## Planning Report- 16 housing units, Distillery Lane, Midleton

The proposed development envisages the construction of a 6 storey apartment block containing 16 no. dwellings on an urban brownfield site. It is intended that the end users of the building would be elderly residents

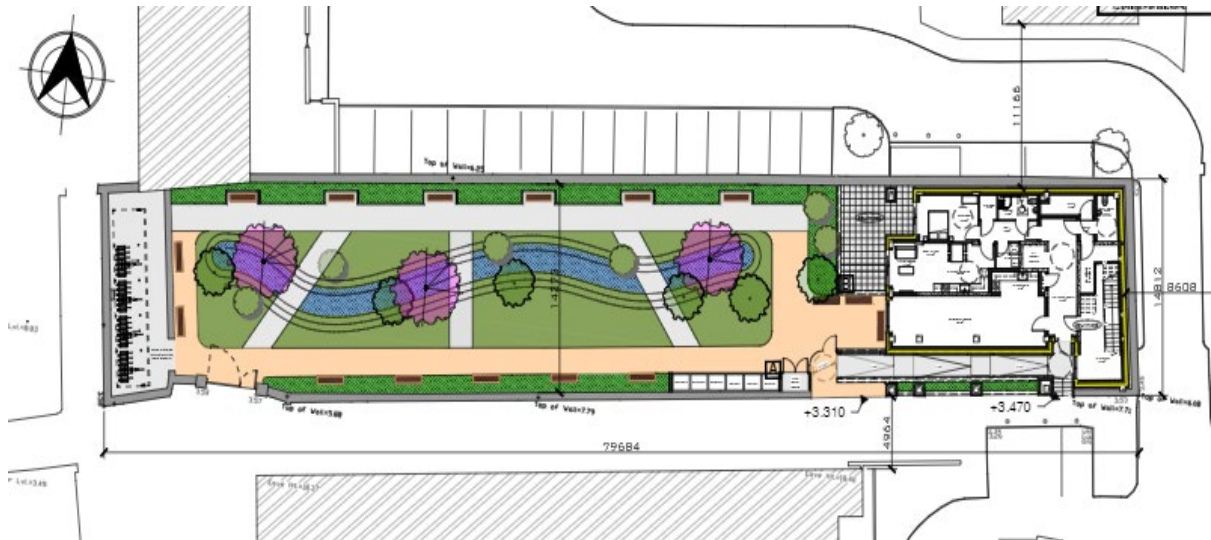
16no. housing units are proposed on an overall site area of 0.11ha equating to an overall density of approx. 138 dwellings/ per ha.

The CDP zoning identifies town centres as being suitable for “high density” development (i.e >50 per ha). In addition, table 3.3 of the recently published “ *Sustainable Residential Developments and Compact Settlements Guidelines (2024)* states that “*residential densities in the range 50 dph to 150 dph (net) shall generally be applied in the centres and in urban neighbourhoods of Metropolitan Towns*”. Outside of this density framework, the “Design Standards for new apartments” (2022) document identifies centrally located urban areas as being the ideal location for apartment developments.

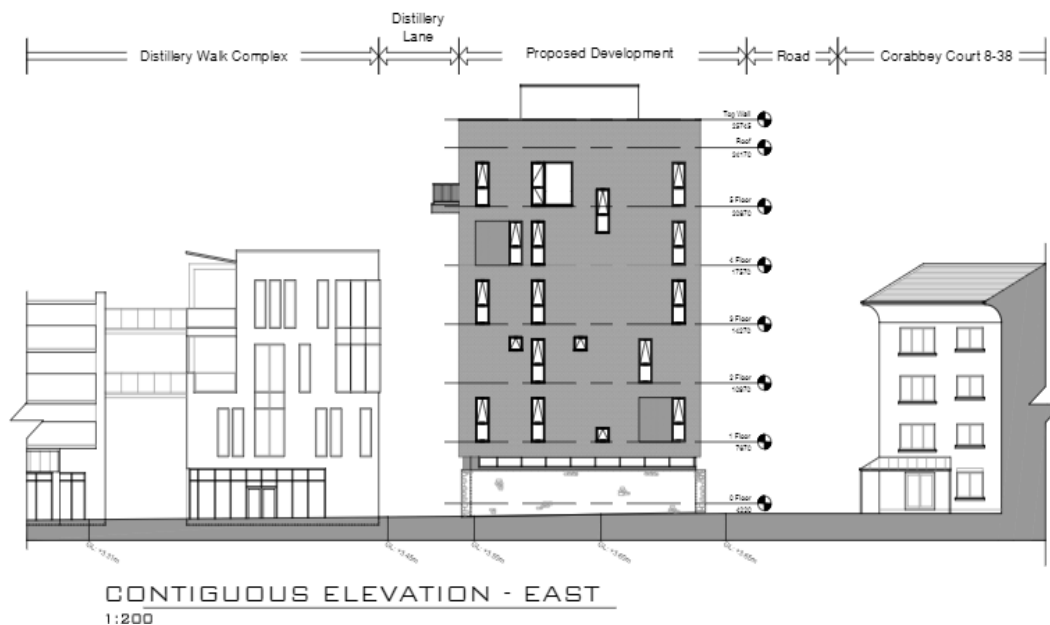
Aesthetically, the site is within a designated Architectural Conservation Area thus the architects section also engaged with the conservation officer. The conservation officer has indicated general satisfaction with the design approach (see appendix A). In relation to the materials used the conservation officer has noted that *"A light coloured textured clay brick – brick in various forms is part of the material pallet in the Middleton area, its use here is broadly*

*speaking acceptable. The brick should weather well and retain a sense of high quality finish which is appropriate within the ACA. The windows are proposed to be aluminium and balcony rails to be steel – again this should weather well and retain a strong sense of quality finish over time..”*

The building itself is a six storey structure (22m) though it has a narrow overall width (18.8m). There are 3 apartments proposed for each floor with a single unit and community room on ground floor. Surrounding heights tend to range 3-4 storey. A photomontage has been submitted to support the overall height. While it is taller than its immediate surrounds, it will not be visible from main street nor will it form a conspicuous structure across the wider settlement where taller structures are more readily visible (i.e Midleton Distillery to the East). Furthermore the building also fronts a large surface car parking area thus the character of this area is less defined with a variety of building types and uses in the vicinity. Scope therefore exists for an individual structure of the type proposed.

Figure 20. Site plan showing relationship to existing buildings.

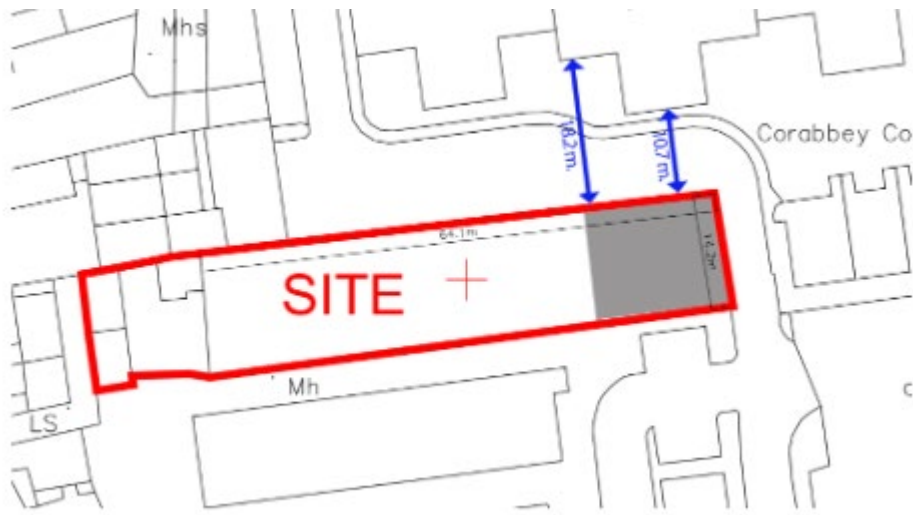
The proposed development has been considered in terms of its impact on the residential amenity of surrounding property. To this end, it is noted that the majority of the proposed living room/ balcony openings are positioned on the Western side of the building where they face the community garden area. As a result, these balcony areas retain a separation distance of approx. 50m to the neighbouring development to the West do not directly overlook any private garden spaces. The balcony areas are also recessed within the footprint of the building to prevent lateral overlooking of the developments to the N and S.

The most potentially vulnerable development is located to the North (the Corabbey Court development). Openings on the Northern elevation are limited and the narrow overall width of the proposal means the overall span of potentially overlooking windows is concentrated on a relatively small element of the Corabbey court development. The design statement submitted with the drawings notes that there is a separation distance of 16m between these opposing upper floor windows (a distance recommended in the *The Sustainable Residential Development and Compact Settlements Guidelines*) In the instance where it falls beneath that figure, it is highlighted that *the façade of the opposite existing building contains what appears to be a circulation core with no windows to habitable spaces (see images below)*

With regard to overshadowing, the positioning of the structure on the Eastern end of the plot means there will be no significant overshadowing of the distillery lane development to the SW. Similarly, and as noted above, the narrow overall width of the proposal should limit overshadowing of Corabbey court development directly North. An overshadowing analysis has also been submitted which demonstrates this position.
